RE: OCONEE STATION, UNITS NOS. 1, 2 & 3

Enclosure:
 Burnup-Dependent Correction
 for Fission Gas Release
 Models

Enclosure 1

FIGURE 1

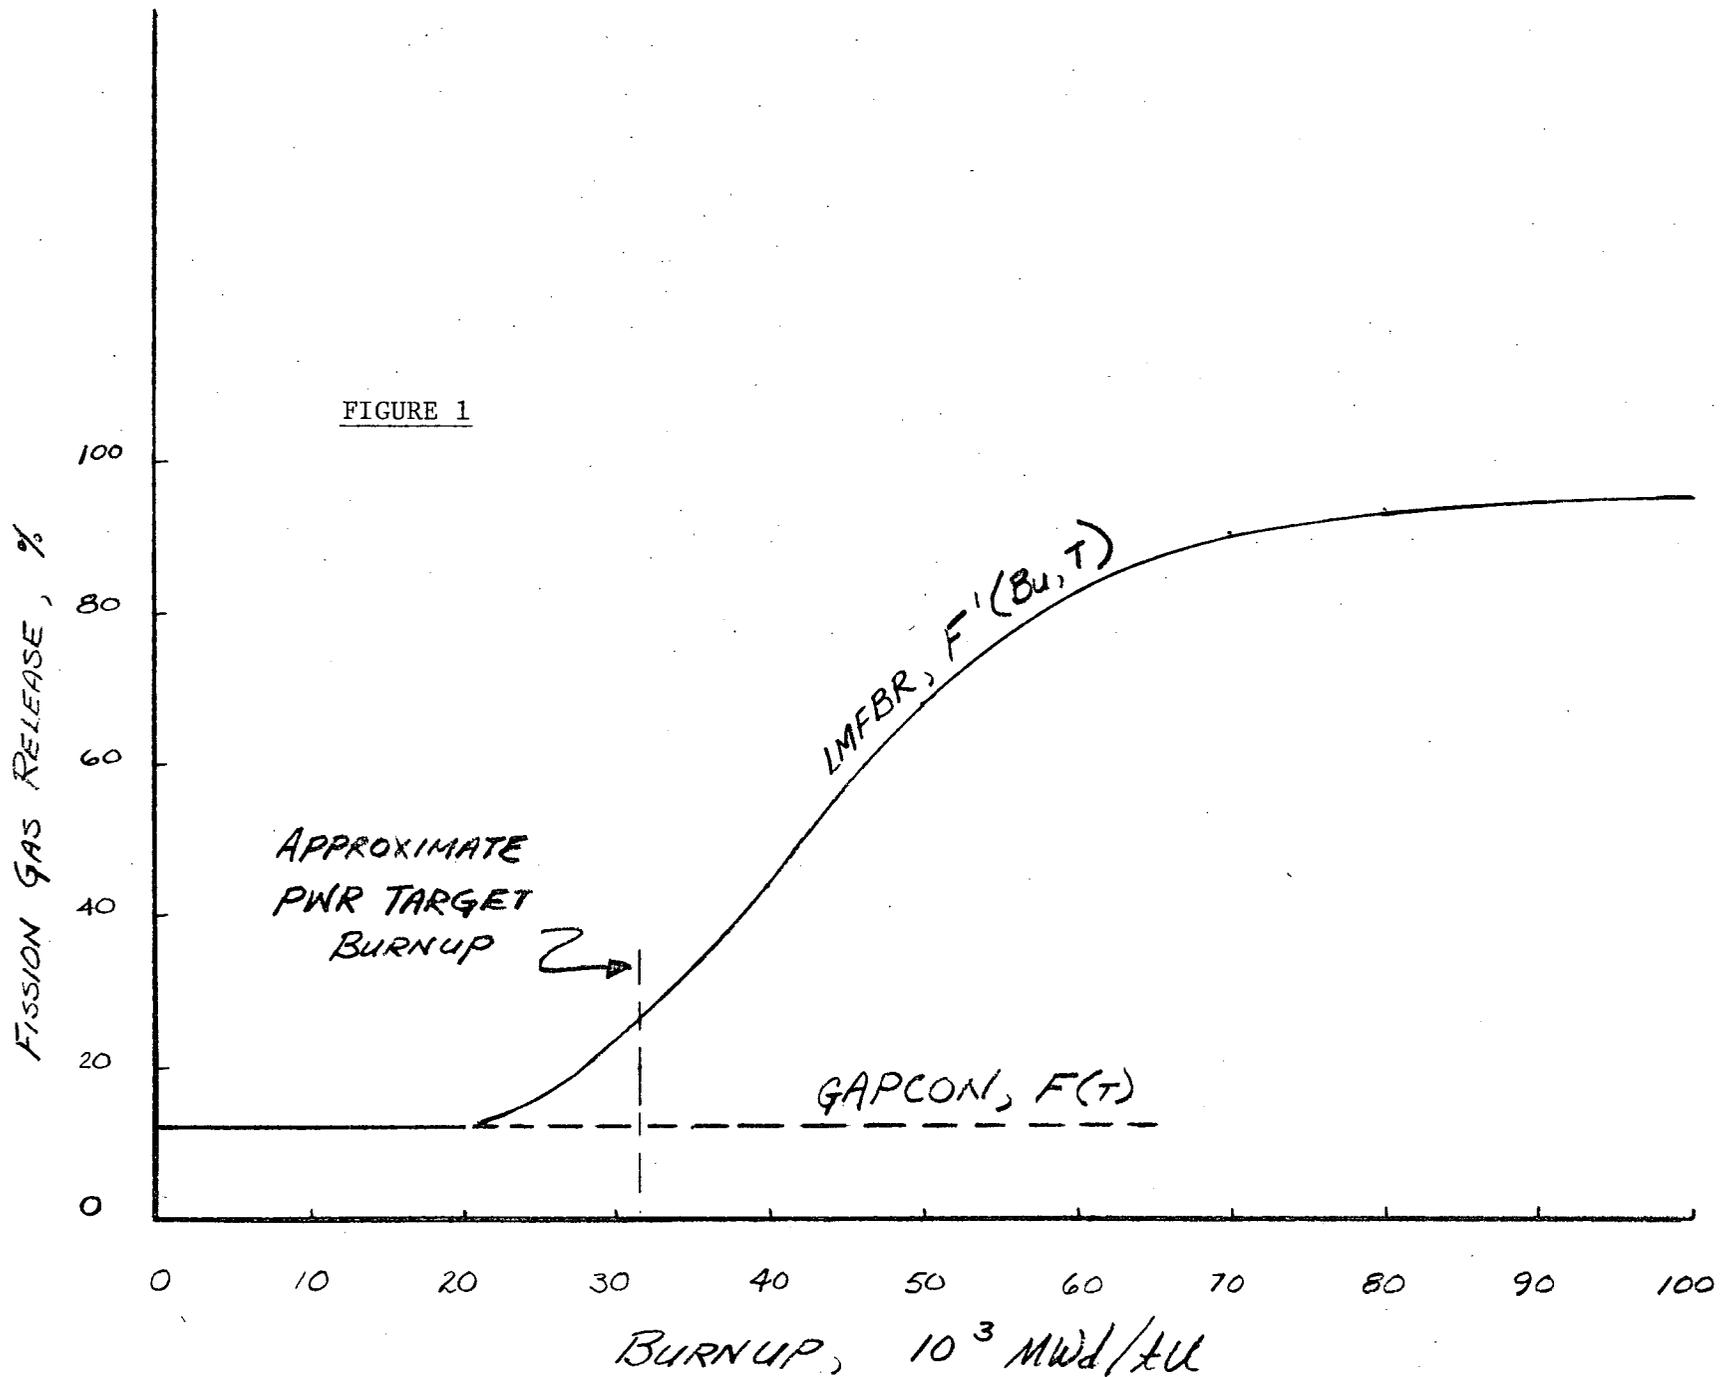
Figure 1 shows schematically how this correction would be applied to the GAPCON gas release model, which is independent of burnup. In the event an existing model contains a burnup dependence, $F(T)$ would be the predicted release fraction under the temperature conditions of interest, but with the burnup variable set equal to 20,000 MWd/tU.
